SOUTHERN CLOTHINGS LIMITED (EXTENSION-2)

Bottola, Zirabo, Ashulia, Dhaka

9 February 2025

2. Observations

Observation 01: Lack of design report, material test report and foundation details. (Building-2 Wash)

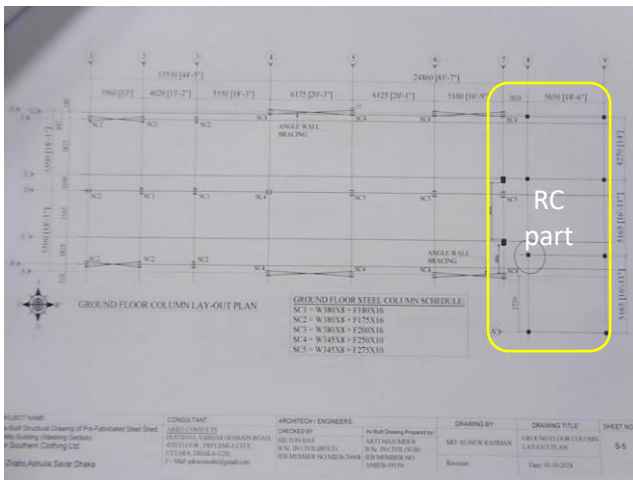
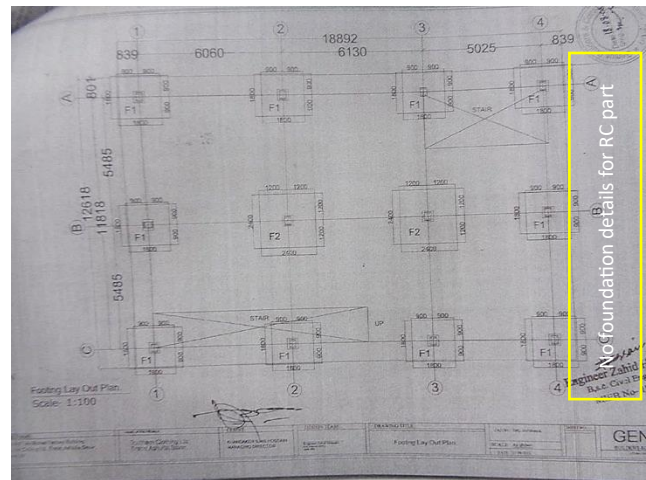
Description: The building consists of steel and reinforced concrete parts. It was extended horizontally, adding seven bays instead of the three shown in the permit drawings. No design documents exist for the current structure. The provided structural drawing lacks foundation details for the RC part, and the foundation details for the steel section do not reflect the as-built condition. There is no in-situ material test report for the building. Furthermore, there is no continued lateral load transfer media (compression strut) in the lateral load resisting system in the roof.

The building engineer is required to carry out Detail Engineering Assessment (DEA) for the structure to verify the foundation details, in-situ material strength, check the design against lateral forces, stresses and serviceability's. Prepare a full set of DEA documents with detailed remedial action plan. Submit the DEA documents to the RSC for review.

Observation 02: Mismatch between drawing and as-built condition (Building-2 Wash)

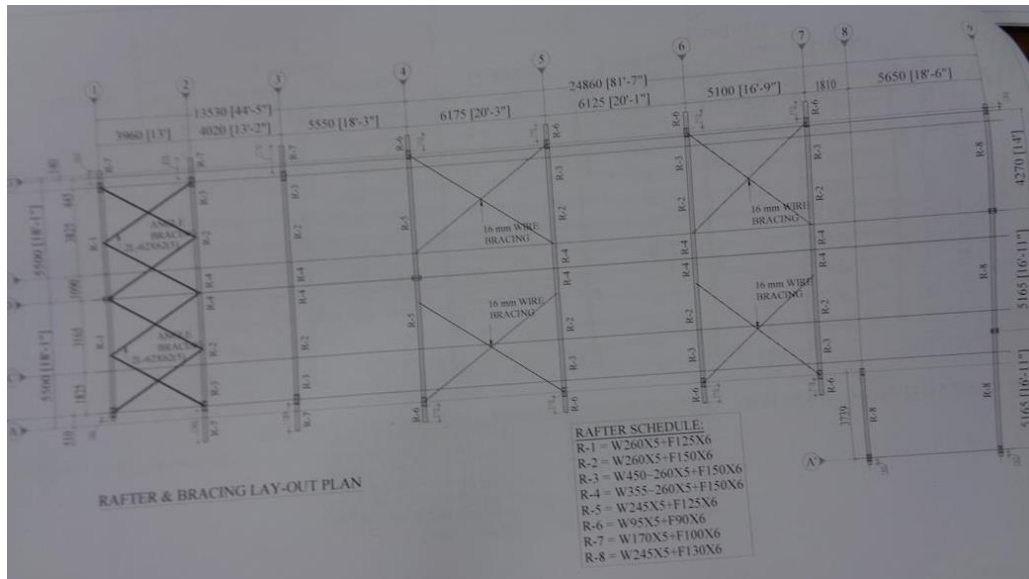
Description: Foundation details of RC part were missing. Discrepancies were observed for almost all column grids (around 150 mm variations), rafter sizes (125 mm flange width instead 150), bracing layout & sizes (50 mm angle instead of 75mm), RC column sizes (250 mm instead 375 mm). Also, toilet zone with min. 300 mm floor raise was found on 1st floor which was not mentioned in the drawing.

The building engineer is required to survey the structure, prepare accurate as-built drawings with foundation and connection details.

Observation 09: Inconsistency in the Building Permits (Building-2 and Building-7)

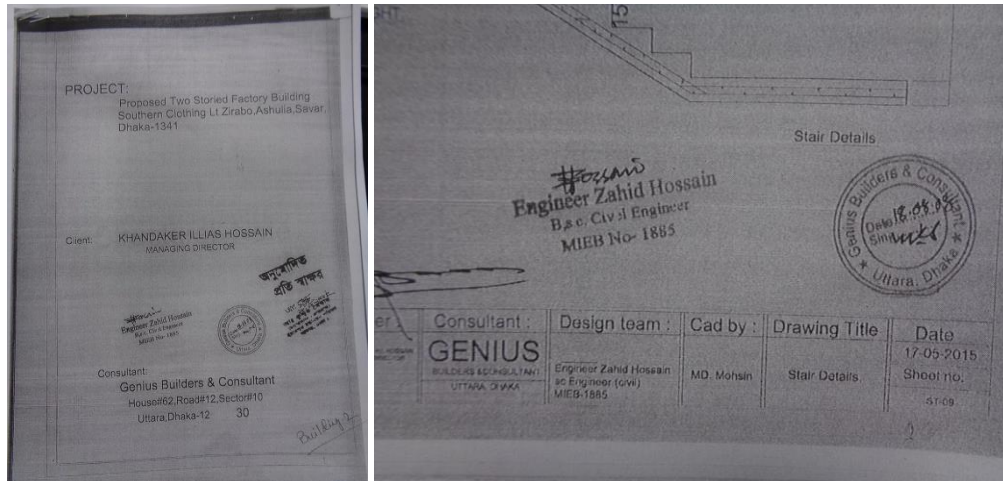
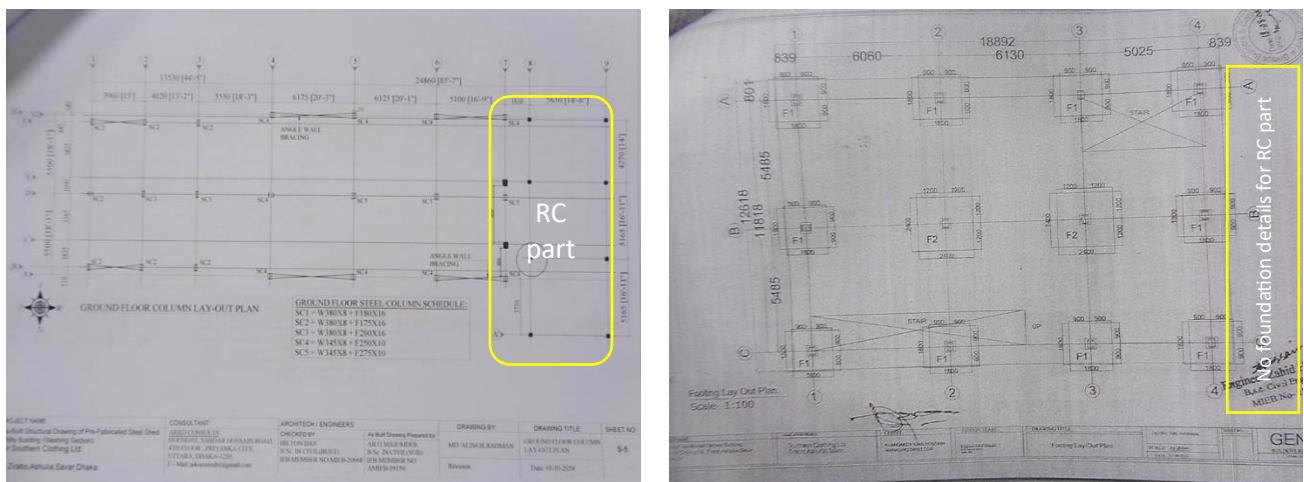
Building-2 Wash: Permit date 18 August 2008, on structural drawing prepared on 17 May 2015

Building-2 Wash: Permit didn't reflect the as-built construction, a portion of building is missing in permit drawing

Description: The building permit for Building-2 Wash didn't reflect the actual building layout. Also, the date of drawing and date of permit create confusion regarding the authenticity of the permit. The building permit for Building-7 Dining was not taken from BNBC-2020 prescribed local authority. The factory is required to collect building permits from BNBC prescribed local authority.

Observation 10: Revision of design report based on in-situ material strength (Building-7 Dining)

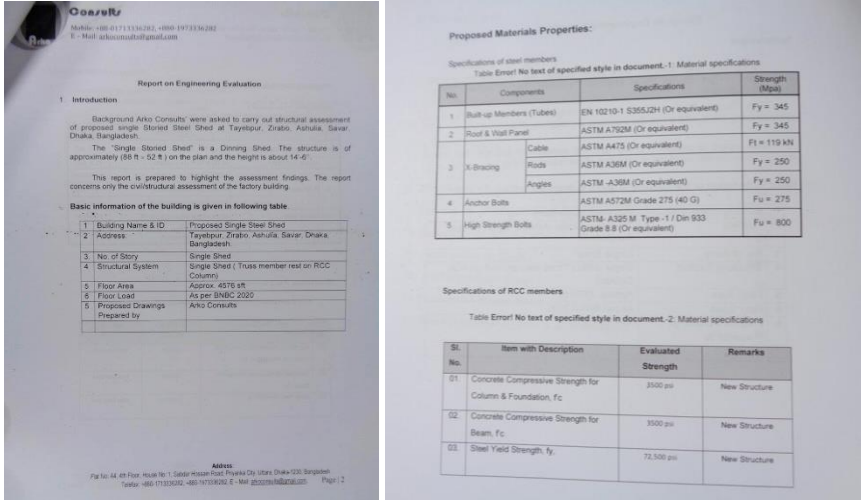
Description: A set of design reports was available for the shed. Steel material strength considered 50 ksi without test report. The building engineer is required to verify in-situ material strength and revise the design documents accordingly.
